**James City County Environmental Division
Stormwater Management/BMP Record Drawing &
Construction Certification Review
Tracking Form**

- Project Name: Whitting Funeral Home BMP #2
County Plan No.: SP-006-07
Stormwater Management Facility: DRY SWALE
BMP Phase #: I II III
 Information Package Received. Date/By: 6/30/2009 Jamestown Construction LLC
 Completeness Check:
 Record Drawing Date/By: 6/29/09 Jeffrey J. Vierretter
 Construction Certification Date/By: 6/25/09 Douglas Mi Will
 RD/CC Standard Forms (Required for a BMPs after Feb 1st 2001 Only)
 Insp/Maint Agreement # / Date: 070025277 9/7/2007
 BMP Maintenance Plan Location: Sheet C 5.1 Item 4
 Other: _____
 Standard E&SC Note on Approved Plan Requiring RD/CC or County comment in plan review
 Yes No Location: C51
 Assign County BMP ID Code #: Code: CC037
 Preliminary Input/Log into Division's "As-Built Tracking Log"
 Add Location to GIS Map. Obtain basic site information (GPIN, Owner, Address, etc.)
 Preliminary Log into Access Database (BMP ID #, Plan No., GPIN, Project Name, etc.)
 Active Project File Review (correspondence, H&H, design computations, etc.)

RECORD DRAWING OF BMP
 FOR
WHITING FUNERAL HOME
 JAMES CITY COUNTY V

SHEET
D1.2
3 of 3 Sheets
SCALE: AS SHOWN
PROJ. NO.: 05224A

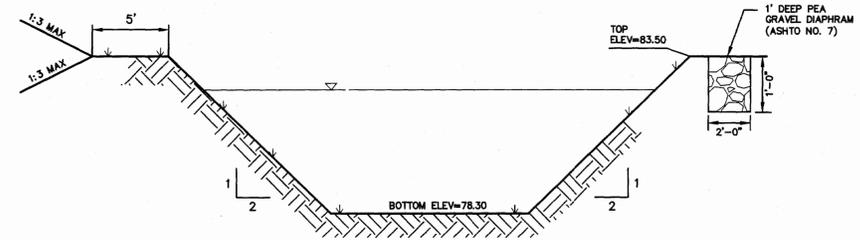
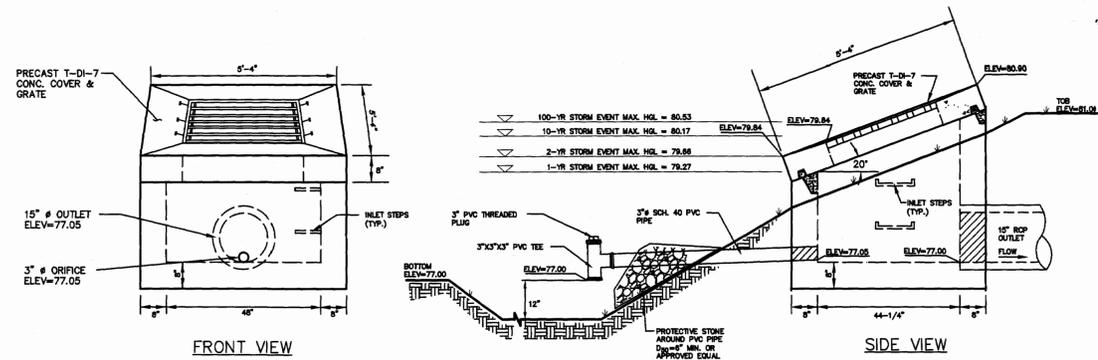
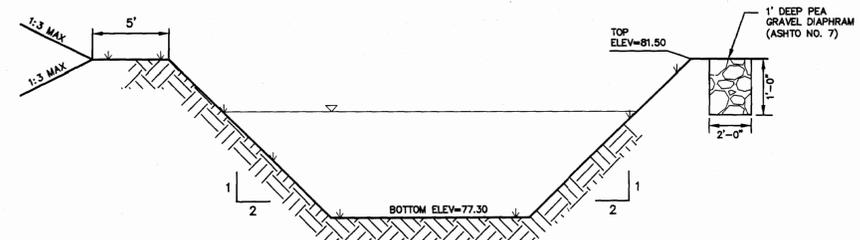
proposed basin are on plan sheet D1.2, but the BMP location information is on plan sheet C5.1. Please make appropriate references in the next submittal.

42. Pond WSEL's. Please revise the water surface elevations provided on plan sheet D1.2 to be horizontal. The way they are currently skewed is confusing and does not represent the true elevations relative to the embankment and gravel diaphragm.
